Responses to comments of Referee #3 to the paper “Integrated response and transit time distributions of watersheds by combining hydrograph separation and long-term transit time modeling”

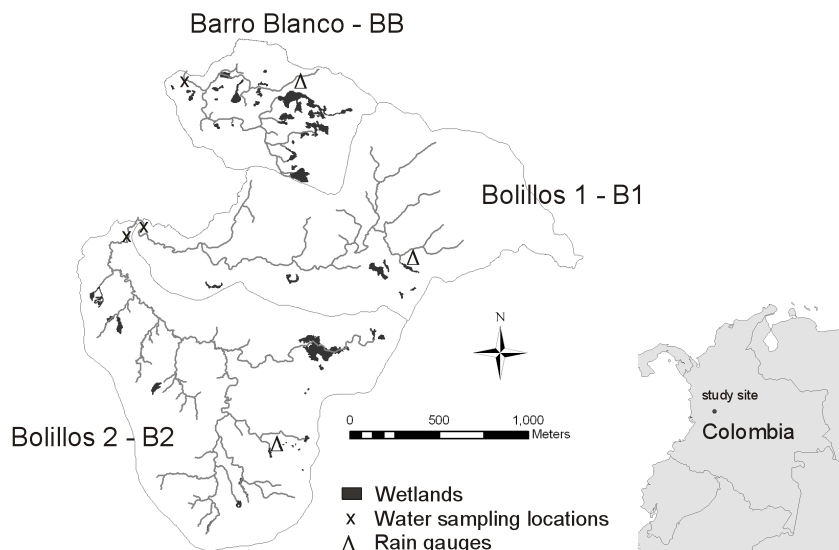
Figure 1: Please add the locations of the precipitation stations.

Revised
